## Executive Director's Recommendation

Commission Meeting: January 7, 2016

<b>PROJECT</b> <b>Martin Luther King Jr. Memorial Library Rehabilitation and Modernization</b> 901 G Street, NW Washington, DC	<b>NCPC FILE NUMBER</b> 7610
<b>SUBMITTED BY</b> District of Columbia Public Library	<b>NCPC MAP FILE NUMBER</b> 21.00(38.00)44009
<b>REVIEW AUTHORITY</b> 40 U.S.C. § 8722(b)(1) and (e)	<b>APPLICANT'S REQUEST</b> Approval of comments on concept design
	<b>PROPOSED ACTION</b> Approve comments as requested
	<b>ACTION ITEM TYPE</b> Staff Presentation

**OPTION 1: FULL GLASS**

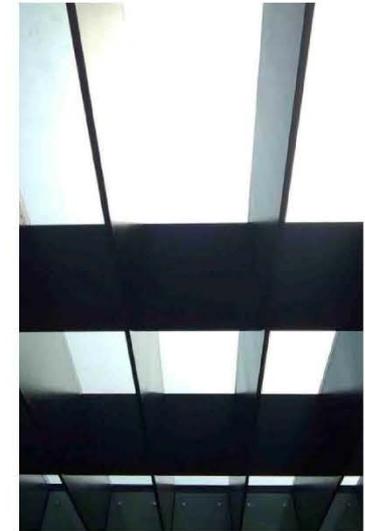
- Entrance Vestibule - Continue consultation with the appropriate review bodies regarding the use of glass in the entrance vestibule. The Commission supports the library's efforts to introduce a greater degree of transparency and invite visitors to explore the building.

Staff recommends that the Commission request that prior to preliminary review, DCPL continue to consult with the appropriate review bodies regarding the use of glass in the entrance vestibule, and supports the library's efforts to introduce a greater degree of transparency and invite visitors to explore the building.

## FIRST FLOOR PLAN (RAMP OPTION)

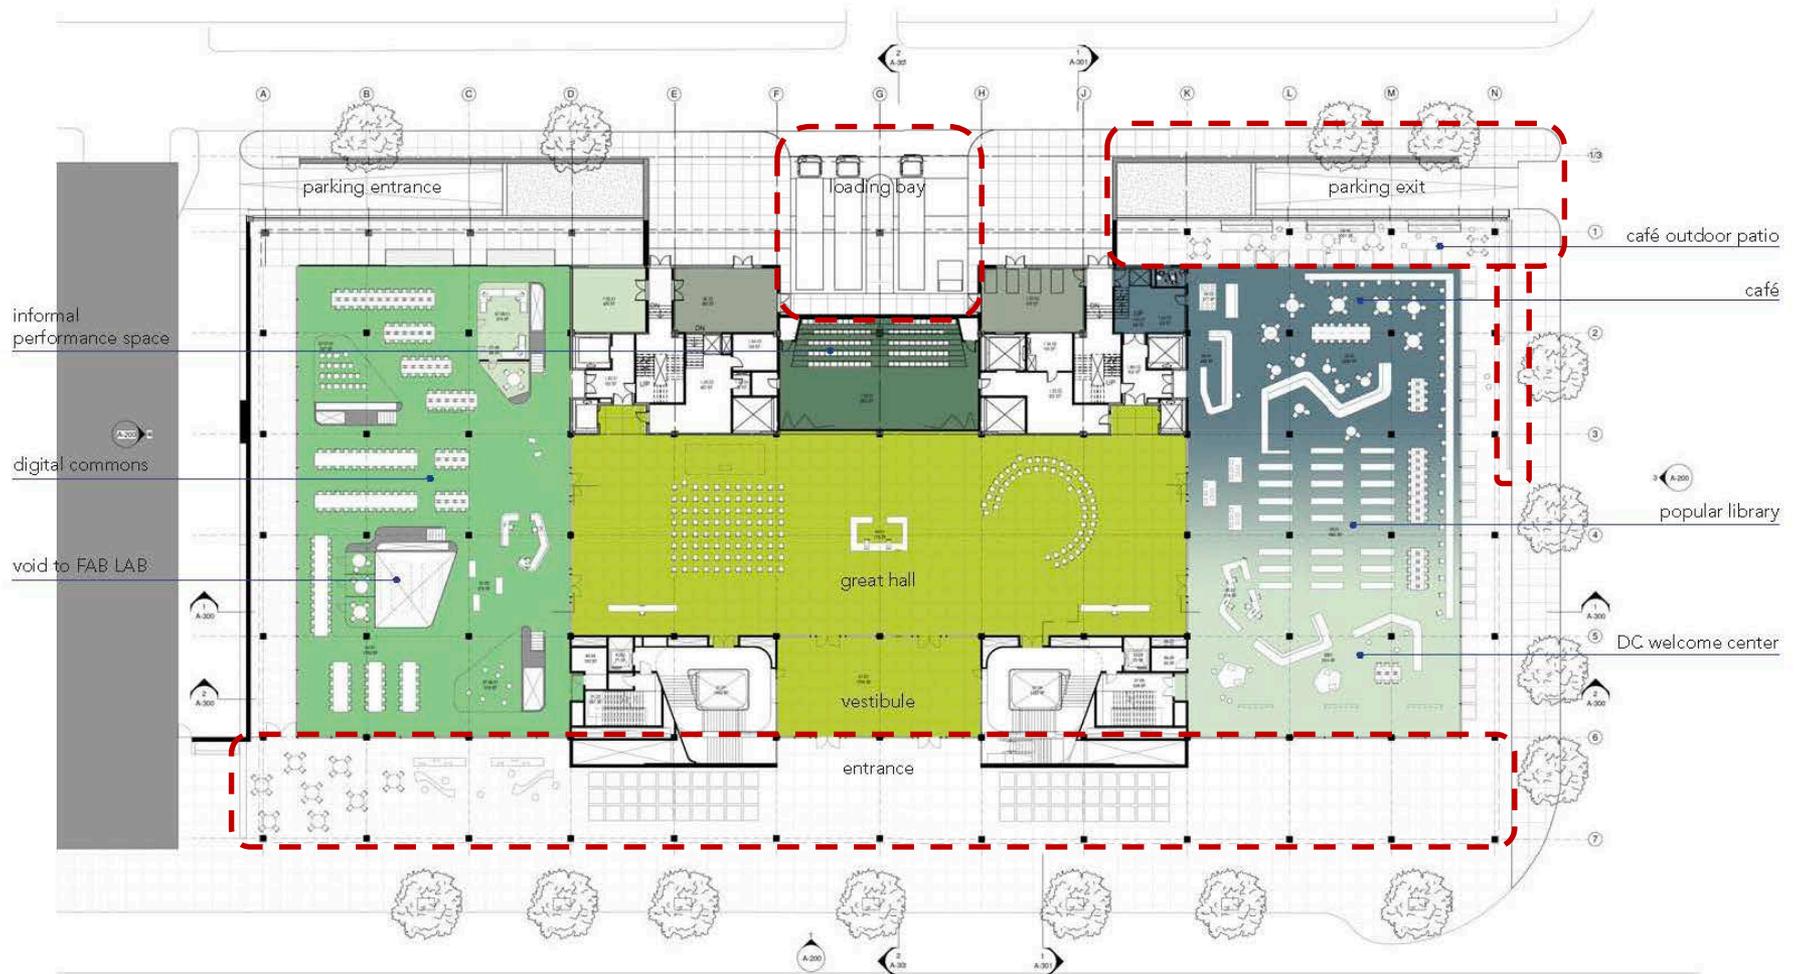
**Notes** that the exterior wall adjacent to the vehicle ramp along 9<sup>th</sup> Street is a historic element and a character-defining feature of the building, however it blocks views to and from the building and

presents a public safety issue. Therefore, the Commission strongly supports lowering the wall and eliminating the east vehicle ramp along 9th Street, NW in Options 2 and 3 to:

**Does not support** the retention of the east vehicle ramp along 9<sup>th</sup> Street, NW, Option 1, as it would not allow for an open, accessible public space that would connect MLK Library visually and physically to the city.

Staff recommends that the Commission not support the retention of the east vehicle ramp as shown in Option 1. Retention of the ramp would minimize adverse effects on historic fabric, however, urban design principles such as creating a vibrant streetscape would not be achieved. While a small public outdoor space would be provided, it would be constricted by the adjacent vehicle ramp, and the space would not be as inviting or attractive to visitors. In addition, as the vehicle ramp and G Place, NW are located directly adjacent to one another, there would continue to be conflicts between vehicles turning right onto 9<sup>th</sup> Street, NW and pedestrians. Overall, retention of the ramp would contribute to a poor visual connection between the building and surrounding city environment. Providing an open, accessible and inviting public realm at the library would be a significant design improvement to the site and retention of the east vehicle ramp would not allow for that vision to be achieved. Therefore, staff recommends that the Commission not support retention of the east vehicle ramp as it would not allow for an open, accessible public space that would connect MLK Library visually and physically to the city streetscape.

Remove both vehicle ramps

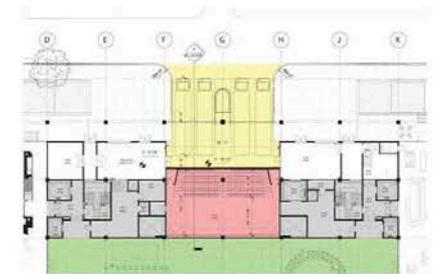
Staff's position regarding the vehicle ramps and open space around the building is that the project presents a prime opportunity to address the original configuration of the site walls. The site walls, though a character-defining feature of the building, block views to and from the building and present a public safety issue. In addition, the location of the vehicle ramp directly adjacent to G Place contributes to conflicts between pedestrians and cars. Therefore, though alterations to the site walls would be an adverse effect on the historic property, balancing historic preservation and planning considerations is a key component of the site design. Staff recommends that the Commission note that the exterior wall adjacent to the vehicle ramp along 9<sup>th</sup> Street is a historic element and a character-defining feature of the building, however it blocks views to and from the building and presents a public safety issue. Therefore, the Commission strongly supports lowering the wall and eliminating the east vehicle ramp along 9<sup>th</sup> Street, NW in Options 2 and 3 to:

LOADING PLAN

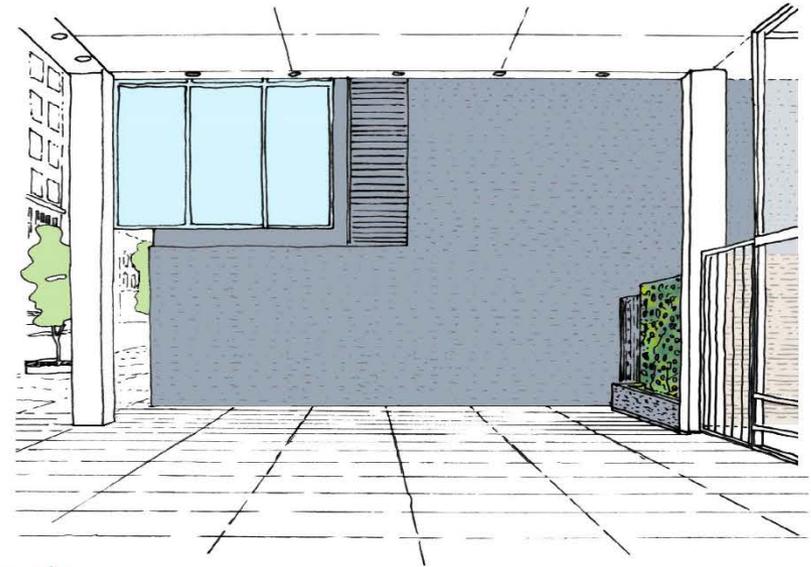
**Requests** the District of Columbia Public Library explore additional landscaping designs and pedestrian amenities in the vicinity of the loading dock to improve the function and aesthetics of the area.

The loading dock is located on the north side of the building and is accessed from G Place, NW. Minor improvements are proposed to the loading dock, but essentially the existing location and configuration will remain in place to accommodate up to 40 foot trucks. A portion of the loading dock will be converted to an informal performance space accessed from the Great Hall which is discussed in more detail below. Staff recognizes that the loading dock is critical to the function of the building as a library, but there appears to be an opportunity to incorporate additional landscaping and pedestrian amenities adjacent to the loading dock. Staff recommends that the Commission request DCPL explore additional landscaping options and pedestrian amenities in the vicinity of the loading dock to improve the function and aesthetics of the area. Such designs should prioritize pedestrian movement by providing a clear, continuous and fully accessible pedestrian path along the street.

## FIFTH FLOOR PLAN

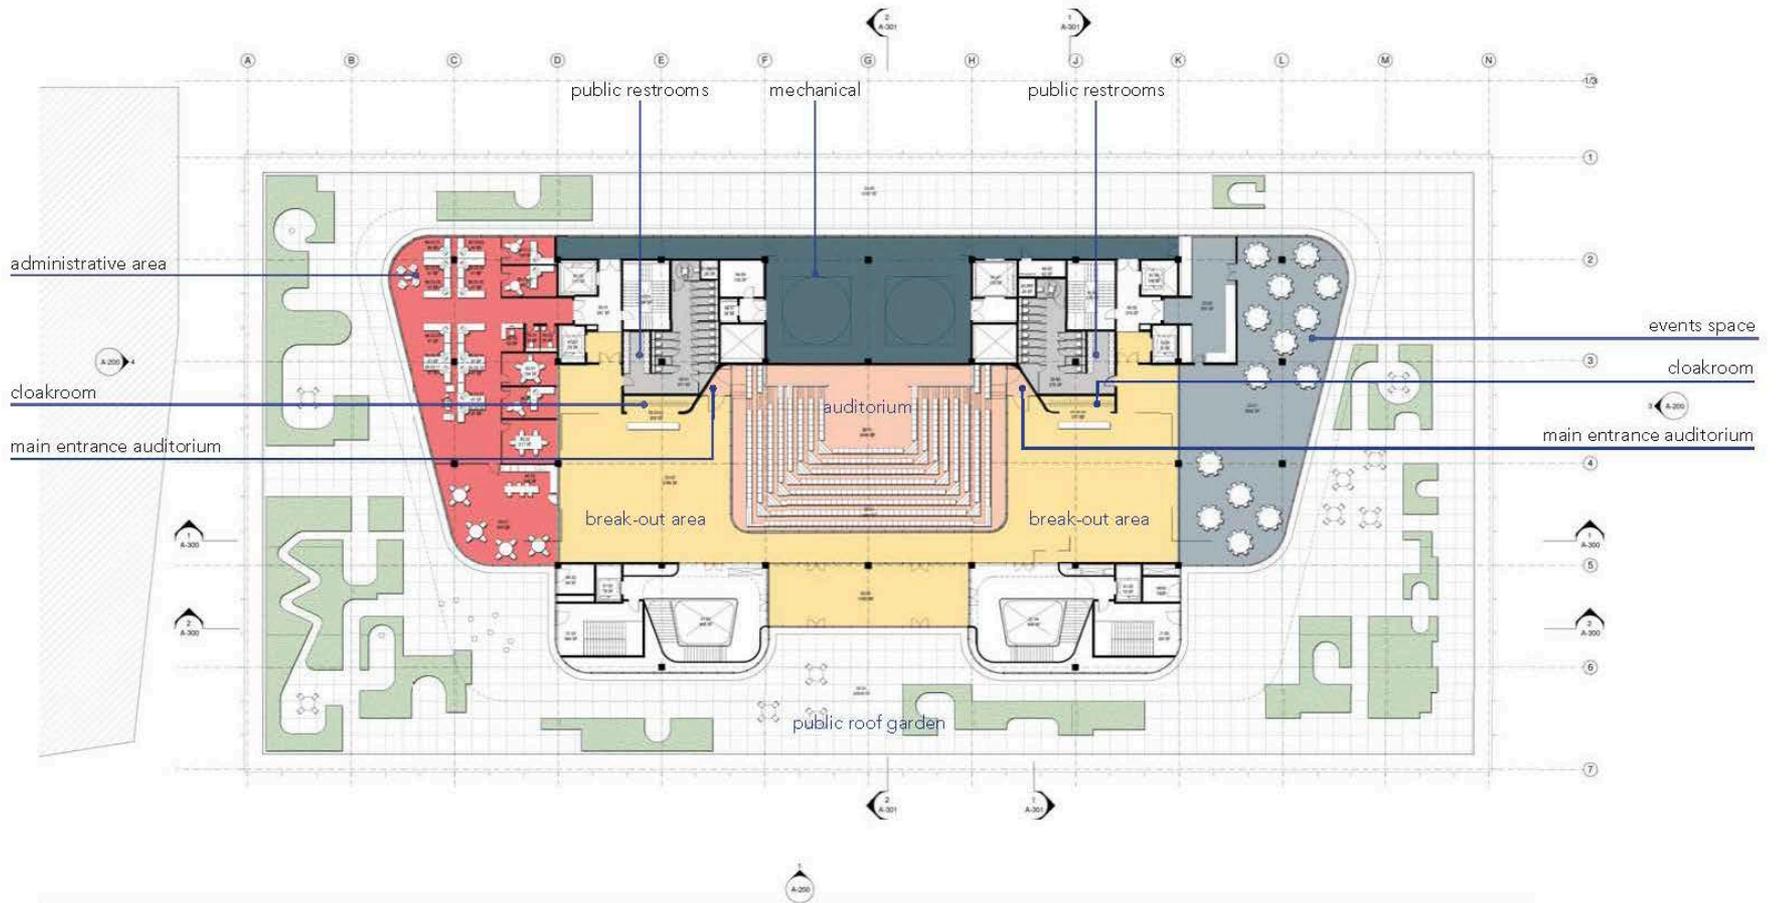
**Notes** the proposed rooftop addition is consistent with the Secretary of the Interior's Standards for Rehabilitation as it is differentiated from the original rectilinear building, but also compatible in terms of its scale, form, and massing.

The most noticeable alteration to the exterior of the building is the construction of the 5<sup>th</sup> floor addition. The addition would have a trapezoidal form with curved corners and a new publicly accessible roof garden will feature a mix of raised planting beds, seating areas, and open space. The roof terrace would be lit to allow for use at night, but uplighting and spotlighting would be minimal. The new addition would feature a green roof for stormwater management. From the corner of 7<sup>th</sup> and G Street, NW, the addition will be minimally visible. From other perspectives along adjacent streets, the addition is setback and it will not be visible. The proposed addition is consistent with the Secretary of the Interior's Standards for Rehabilitation as it is differentiated from the original rectilinear building, but also compatible in terms of its scale, form, and massing. Staff recommends that the Commission note the proposed rooftop addition is consistent with the Secretary of the Interior's Standards for Rehabilitation as it is differentiated from the original rectilinear building, but also compatible in terms of its scale, form, and massing.
